Ordinary Meeting

Tuesday, 27 February 2024

CL01	DA 228/2023 - Electricity Generating Works - 4.9mW Solar Farm and Battery Storage System	
(a)	DA 228/2023 - Combined Submissions.....	3
(b)	DA 228/2023 - Applicant Response to Submissions	34
(c)	DA 228/2023 - Draft Development Assessment Report	82
CL02	DA 240/2023 - Detached Dual Occupancy Development, construction of a new two (2) storey dwelling and retention of an existing two-storey dwelling, with a Community Title Subdivision	
(a)	DA 240/2023 - Draft Conditions of Consent.....	126
(b)	DA 240/2023 - Public Application Plans	141
(c)	DA 240/2023 - Statement of Environmental Effects	147
(d)	DA 240/2023 - Submissions Received	180
(e)	DA 240/2023 - Response to Submissions on behalf of Applicant.....	182
(f)	DA 240/2023 - DA Assessment Report	187

RE: DA 228/2023 RESPONSE TO PUBLIC SUBMISSION - PROPOSED SOLAR FARM (ELECTRICITY GENERATING WORKS) ON LAND AT 2553 MACEDONE ROAD, BEELBANGERA NSW 2680 (LOT 363 DP 751743)

Attachment 1 – Detailed Landscaping Plan

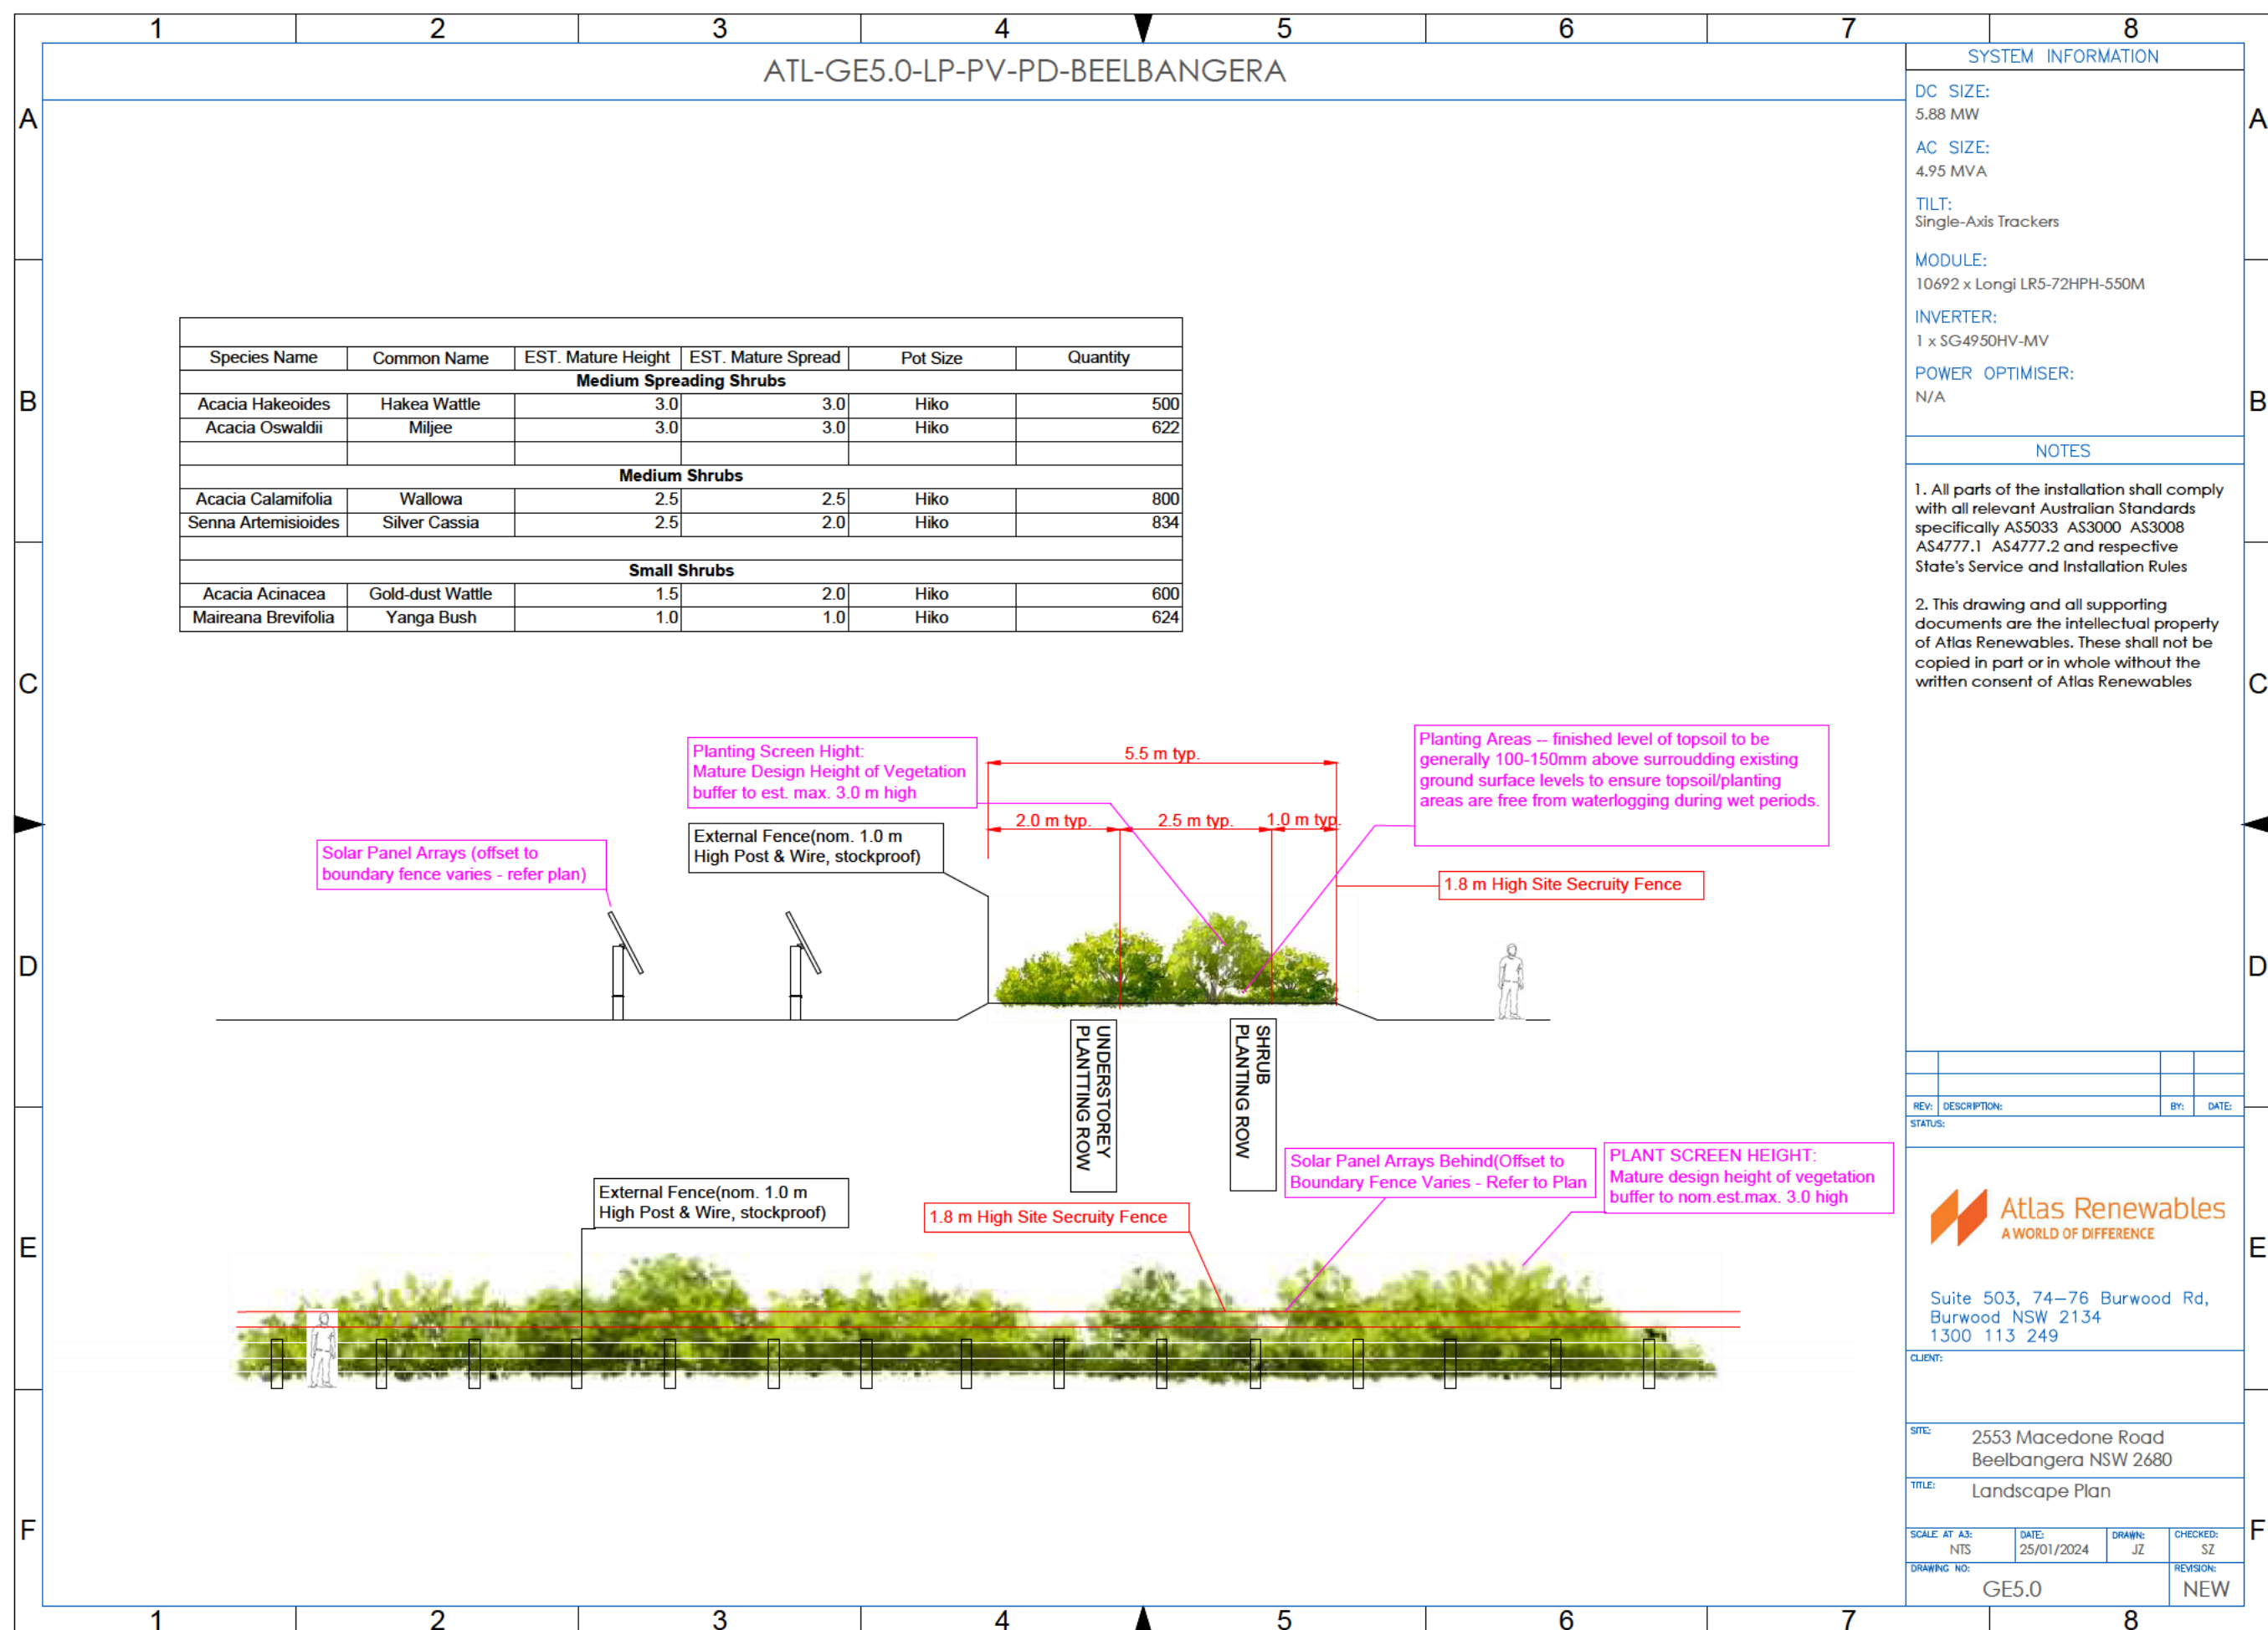
Visual amenity impacts	Submitters are concerned that the proposed solar farm will adversely affect the visual amenity of the locality including scenic rural	<ul style="list-style-type: none"> - In response to this matter, a detailed Landscaping Plan has been prepared (see Attachment 1) which includes a species register and typical section of the buffer planting.

values and that the proposed 1.8m high vegetation buffer planting is insufficient.	<ul style="list-style-type: none"> - As shown on the Landscaping Plan, the planting will consist of a minimum 5m wide buffer comprised of range of species with a maximum height of 3m. - As per the development conditions applied to the recently approved sub 5MW solar farm at 2779 Berecra Road, Tharbogang, Council can condition a mature vegetation buffer around the development to be at least 5 metres deep and comprising at least two rows of staggered trees. - The Griffith Solar Farm (36MW) is almost seven times larger than the proposed solar farm and is set amongst rural landholdings with residences. It demonstrates that a solar farm can be appropriately screened from view and integrate well into the surrounding rural landscape.
Property values	Submitters are concerned that property values will be adversely impacted in the immediate area by the proposed solar farm	<ul style="list-style-type: none"> - Property values can be affected (positively and negatively) by a range of variables and factors. Whilst this is not considered to be a valid planning consideration for assessment, it is unlikely that a small scale solar farm would detrimentally affect property prices in the locality. - As demonstrated in this submitted development application material and in the additional information provided in this response, the proposed development is not forecast to result in any unacceptable amenity or safety impacts and will be visually screened from public vantage points. Accordingly, the project is expected to operate in a manner consistent with the expectation for the RU1 Zone, and with less impact than other rural activities which could ordinarily be expected in a rural area.

Figure 1: First Floor, floor plan. Windows adjoining neighbouring properties circled in neon green.

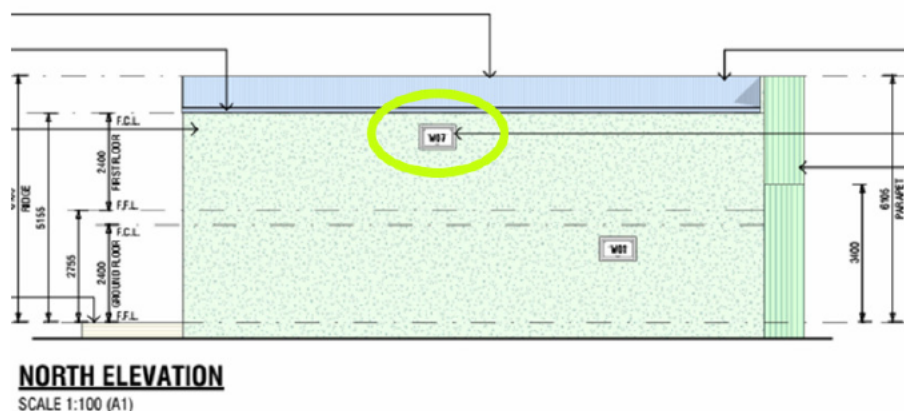
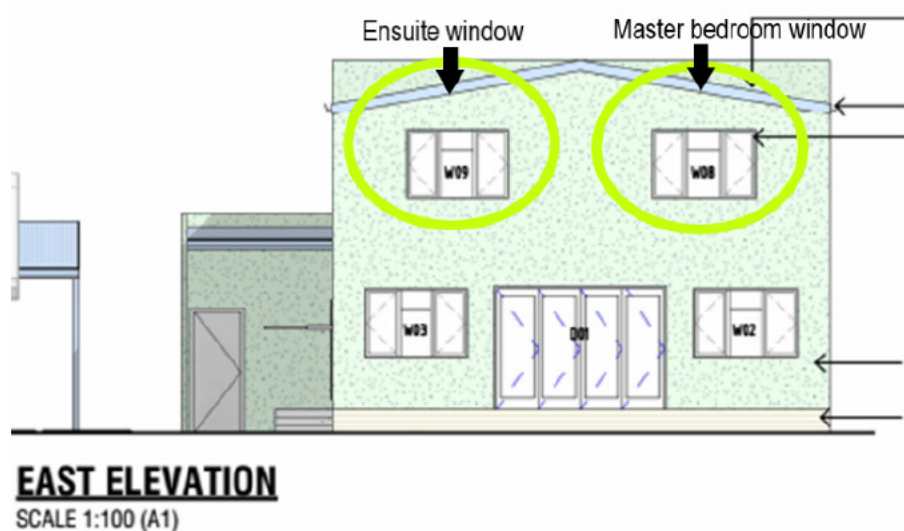
The eastern elevation: The east elevation (opposite 7 Sanders Street) proposes two windows on the first floor. One window in the master bedroom (W08) and another in the ensuite (W09). Both windows propose a 1200mm length x 1800 width, with 900mm to 2100mm height above the floor level. Given that this is the master bedroom and ensuite, with window 9 opposite the shower and basin, the privacy of the occupants is likely desired to be protected. Please see figure 1 and 3 for images of these windows. It is also noted that the proposed dwelling is not directly inline with the dwelling at 7 Sanders Street, so views into windows of this dwelling would not be direct.
